Response to additional technical queries on the Flood Risk Assessment and Drainage Strategy

Oriel
Creating the centre for
advancing eye health

Oriel – Response to additional technical queries on the Flood Risk Assessment and Drainage Strategy – 30th March 2021

Figure 1 Planning Application Boundary and Development Boundary

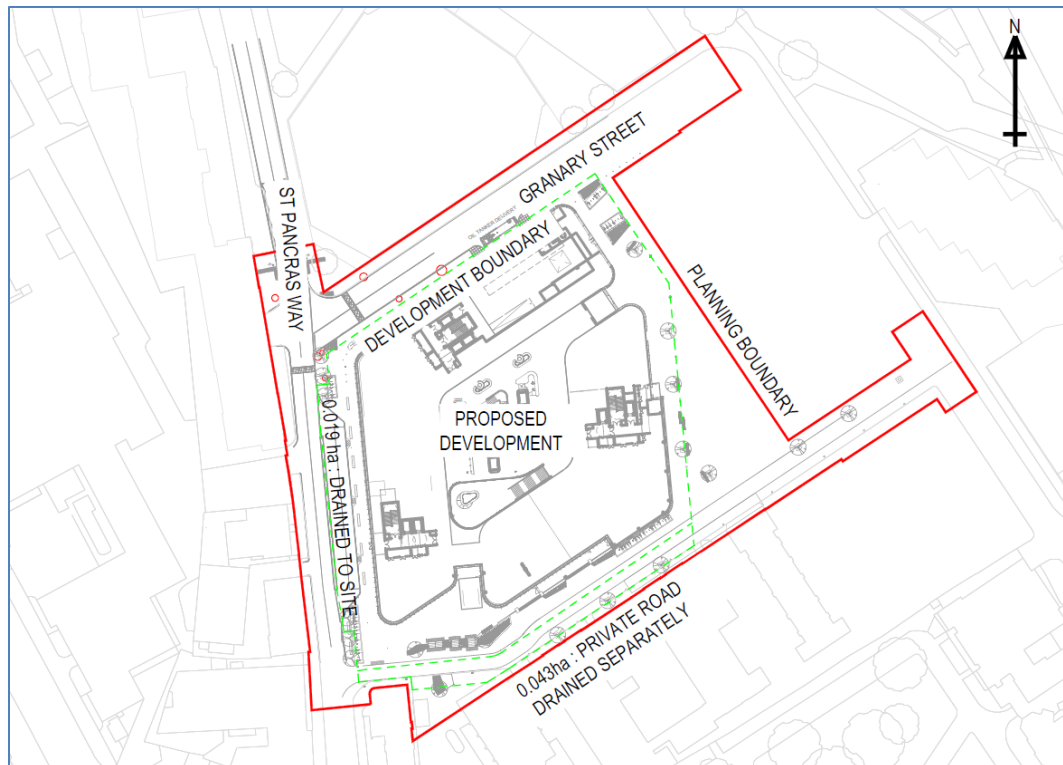
1. Demonstrates why additional highway SuDS have not been considered.

As described in the Flood Risk Assessment and Drainage Strategy (FRADS) (Document Ref. ORL-INF-XX-XX-RP-PL-240-Flood Risk Assessment and Drainage Strategy) submitted with the planning application in October 2020, the Site (i.e. the Planning Application Boundary) covers an area of approximately 1.33 hectares (ha) which includes the proposed building area together with the surrounding public roads and shared private access spaces, as shown in red and referred to as the Planning Application Boundary in Figure 1-1 of the FRADS, and reproduced below in Figure 1.

The area within the Site boundary which is in the control of the Applicant (referred to as the 'Development Boundary', edged in green in Figure 1), has been maximised for the placement of cellular storage attenuation tanks and permeable paving. Very limited space remains within the Development Boundary, immediately adjacent to the building footprint, and this has been reserved for proposed services that will supply the building. Therefore, no space remains within the private curtilage of the proposed building to provide additional SuDS.

External to the proposed building footprint, but within the Planning Application Boundary, are also the existing highways areas that will be reconfigured in some areas (mostly to the west of the proposed building) to facilitate the use of the proposed building. This will include the introduction of a layby to the west of the proposed building. However, no space is available for the inclusion of additional SuDS in the existing highways areas, nor is there a need to drain the existing highways in a different manner to the current arrangement (which would entail significant reconfiguration of the highways and would affect numerous public services that exist along the highways and are not within the control of the Applicant). Therefore, the inclusion of additional SuDS features in the highways areas within the Planning Application Boundary is not feasible.
